Minutes of the Parish meeting held on 17th February 2021 via a remote meeting using Zoom

Appendix 3 - Parish Council comments on application 20/05181/FULMAJ

<u>PLANNING APPLICATION 20/05181/FULMAJ</u>
RESIDENTIAL DEVELOPMENT OF 98 DWELLINGS AT MOOR ROAD, BISHOP MONKTON

A plan is attached showing our suggestions on the layout made in August 2020. This incorporates a central green spine. This is still relevant.

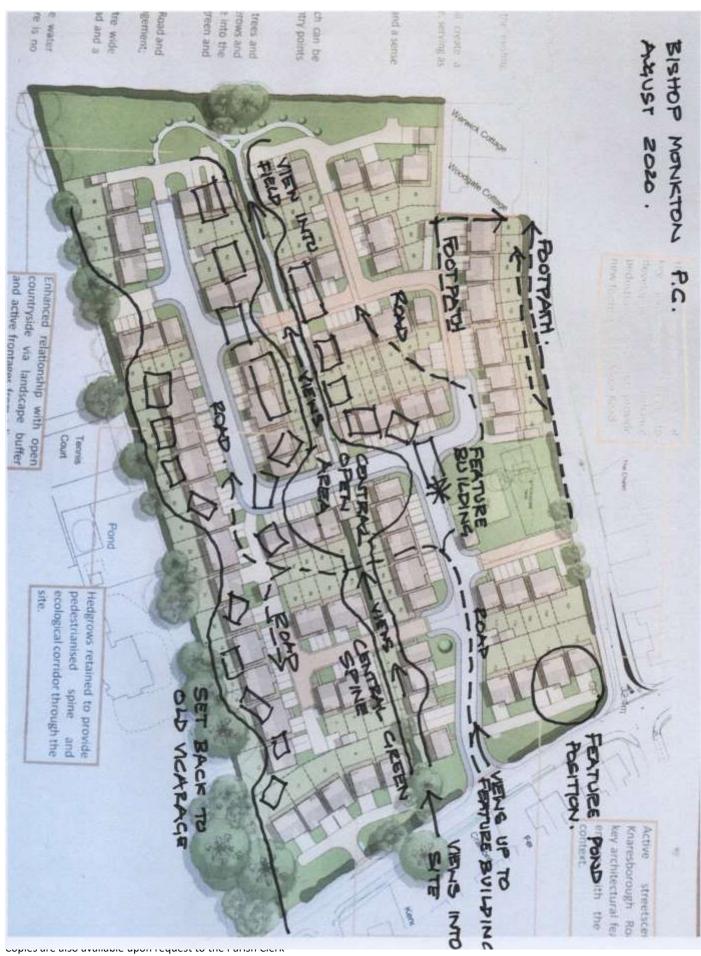
It has also been highlighted that whilst a number of the existing hedges are retained, they are now incorporated into private gardens therefore control over how they are maintained is lost. A central public green spine up the centre of the development as we originally proposed and pulling the development away from the Old Vicarage boundary would help to achieve this and maintain these important features of the site.
